Well Name: CROCKETT	Well Location: T26N / R12W / SEC 25 / NWSE / 36.457269 / -108.058993	County or Parish/State: SAN JUAN / NM
Well Number: 3	Type of Well: CONVENTIONAL GAS WELL	Allottee or Tribe Name:
Lease Number: NMNM94069	Unit or CA Name:	Unit or CA Number:
US Well Number: 300453059400S2	Operator: REDWOLF PRODUCTION INCORPORATED

Type of Submission: Notice of Intent

Type of Action: Plug and Abandonment

Notice of Intent – Plug and Abandonment

Planned P & A Wellbore Schematic

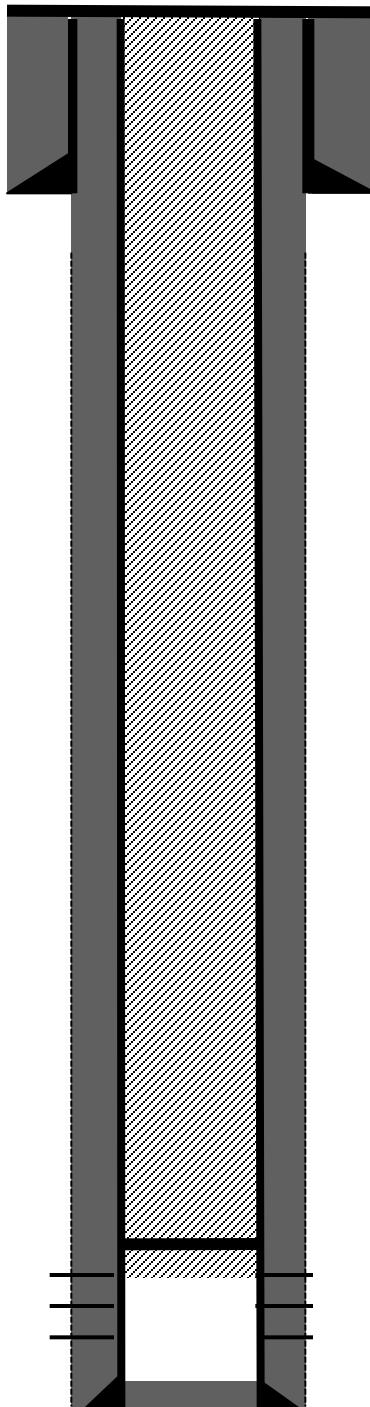
Complete wellbore fill up proposal. No changes to the procedure.

1. Plugging operations authorized are subject to the attached "General Requirements for Permanent Abandonment of Wells on Federal and Indian Lease."
2. The following modifications to your plugging program are to be made:
 - a. Complete wellbore fill up proposal. No changes to the procedure.
3. **Notification:** Farmington Office is to be notified at least 24 hours before the plugging operations commence at (505) 564 7750.
